Thanks for the reviewer's efforts to review this paper. The point-by-point responses are included below with the reviewer's comments in black and our replies in blue.

Reviewer #2

This paper reports on the performance a new radiometer, HSR1, that measures total and diffuse spectral irradiance. HSR1 measured irradiances, diffuse ratio, and derived aerosol optical depths are compared to other spectral and broadband radiometer systems: MFRSRs, SASHe, a Cimel sunphotometer, the RadFlux data product. The instruments operated at the ARM Southern Great Plains site for two months in spring/summer of 2022. The conclusion is that HSR1 measurements of total and diffuse spectral irradiance well in relation to the other instruments, however significant biases exist for irradiance measurements near the tails of the instruments spectral range.

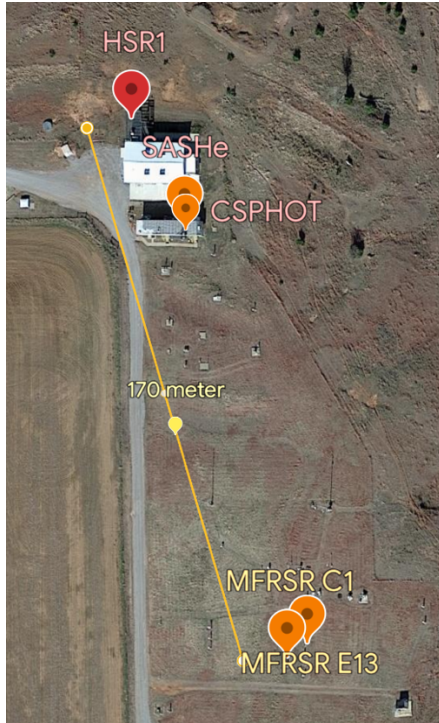
Line 78 – roughly how far apart are the different instruments from each other? It is not easy to infer this from the reported coordinates. A map detailing the locations of the various instruments would be useful.

Thank you for the suggestion. We have added in a map of the instruments’ locations across the site in new Figure 1 (see below), which indicates that the physical distance is 170 m or less.

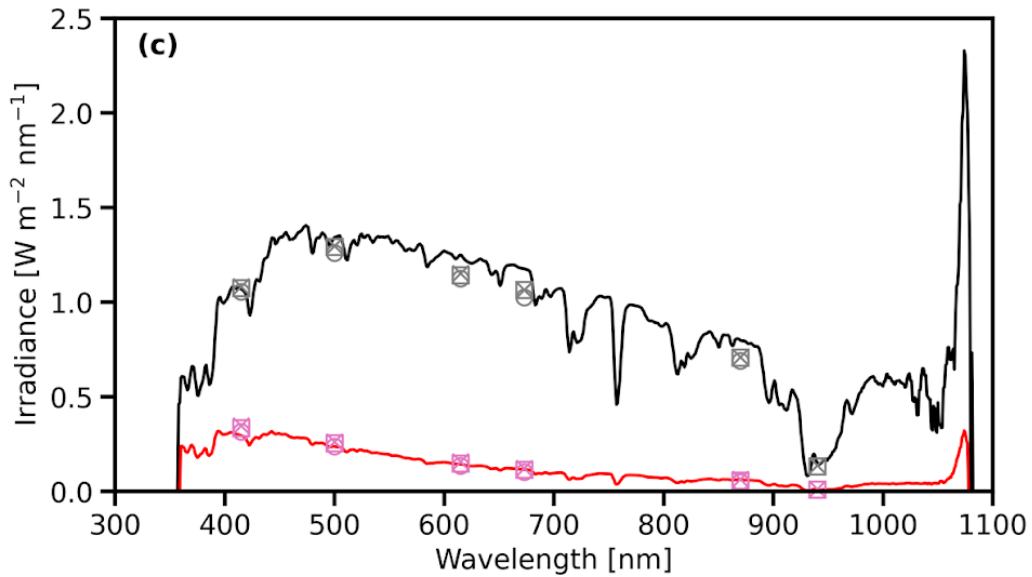
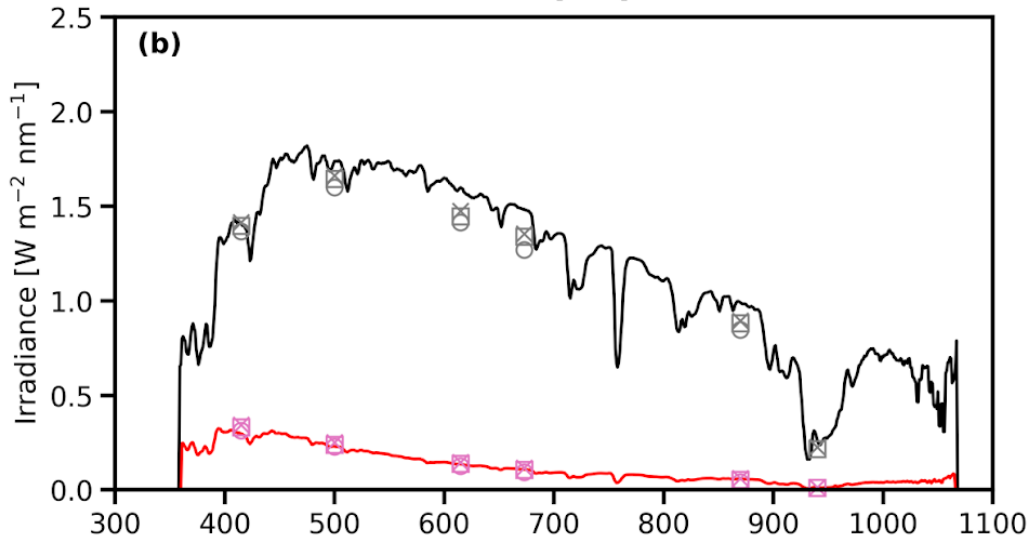
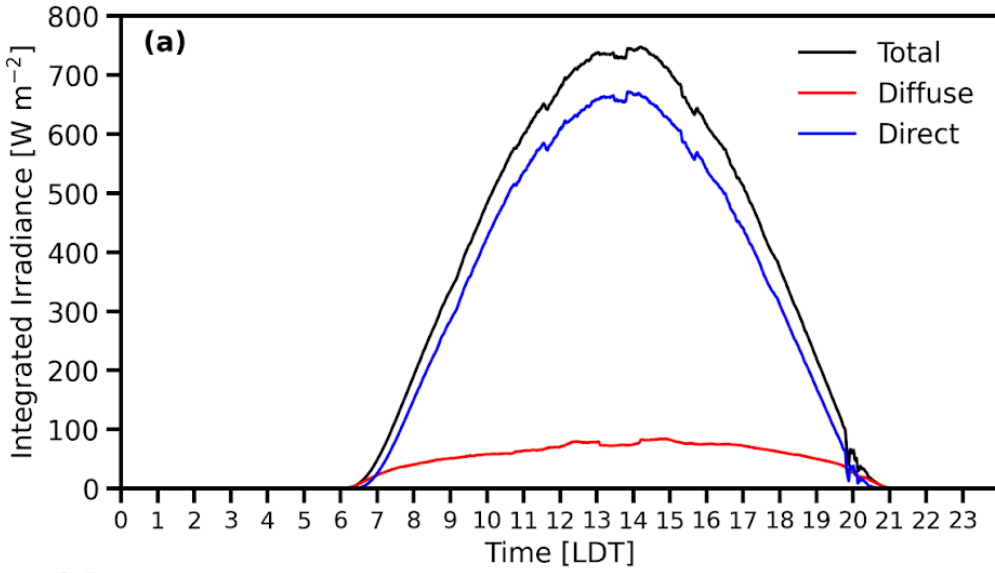
Line 79 – I would move Figure 1 that shows an example of HSR1 irradiance data to a later part of the paper. Also, why not include the comparable irradiance measurements from the other instruments?

Thank you for the suggestion. We have revised Section 2.1 so now Figure 2 (previously Figure 1) is later in the text. We have also updated Figure 2 to include the irradiance measurements from the MFRSRs and SASHe (see revised figure below). Note that the figure has been updated to a different time when all instruments were available.

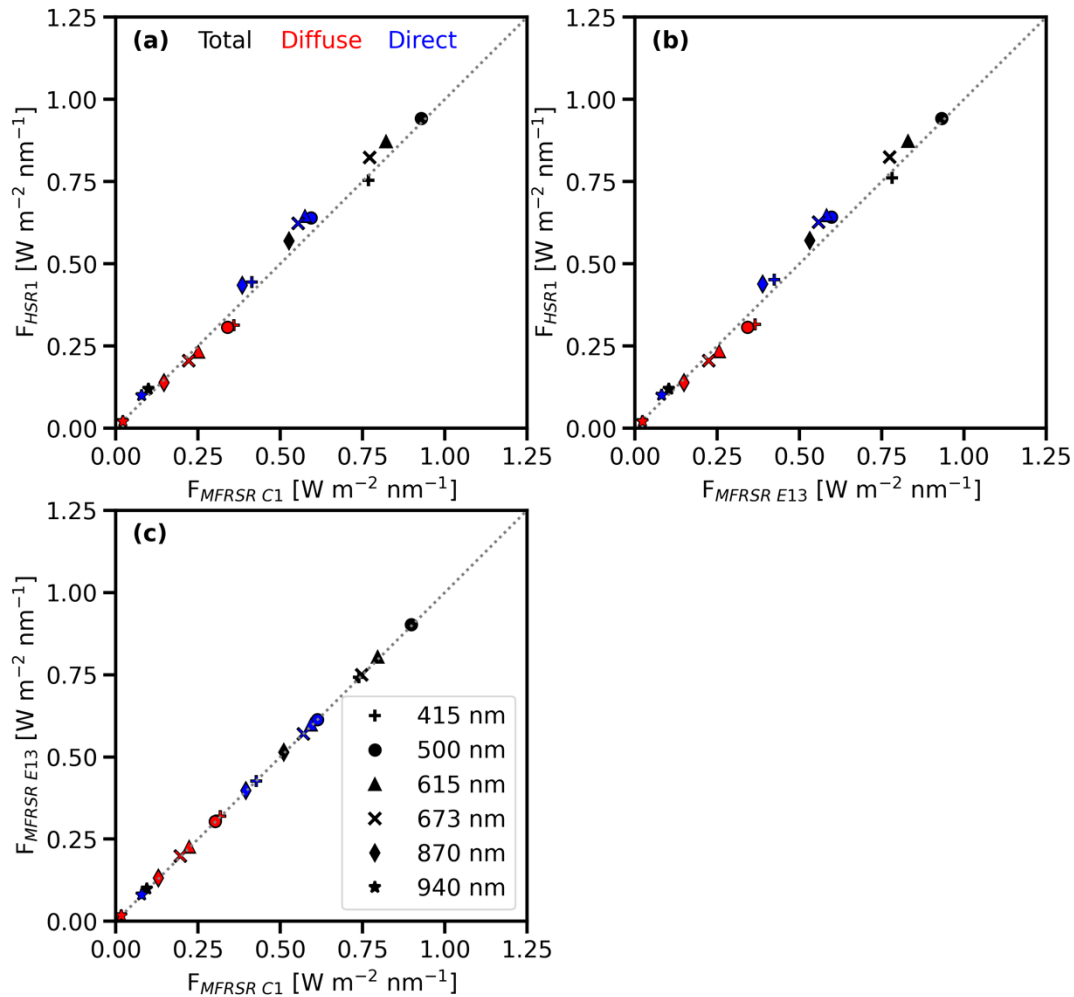
Line 251 – In Figure 4 why not also include the direct irradiance?

We decided to focus on the total and diffuse since this is what is measured by the HSR1. The direct can be inferred by what is included in new Figure 7 (i.e., direct = total-diffuse). We have also plotted the direct irradiance comparison (blue) for your reference.

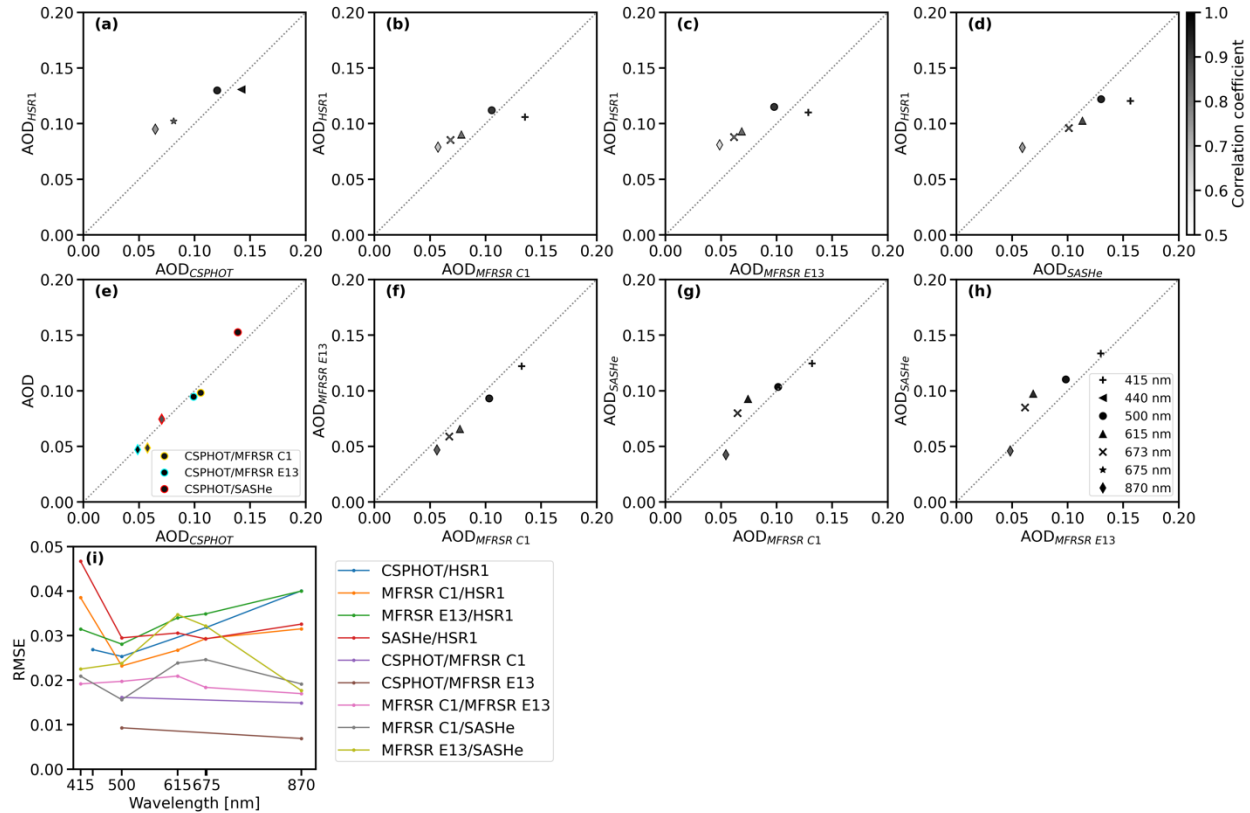
Line 255 – This table is hard to read and interpret and does not hold a lot of utility to the reader. Much of this information is already stated in the text, so I'd either omit the table or present the data in a graphical format.

Thank you for the suggestion. We have removed the tables. For the irradiance comparison, we have presented the correlation coefficients in the text as the values are nearly the same. For the AOD comparison, we have instead presented the correlation coefficients as the color shading in Figure 10a-h (see below).
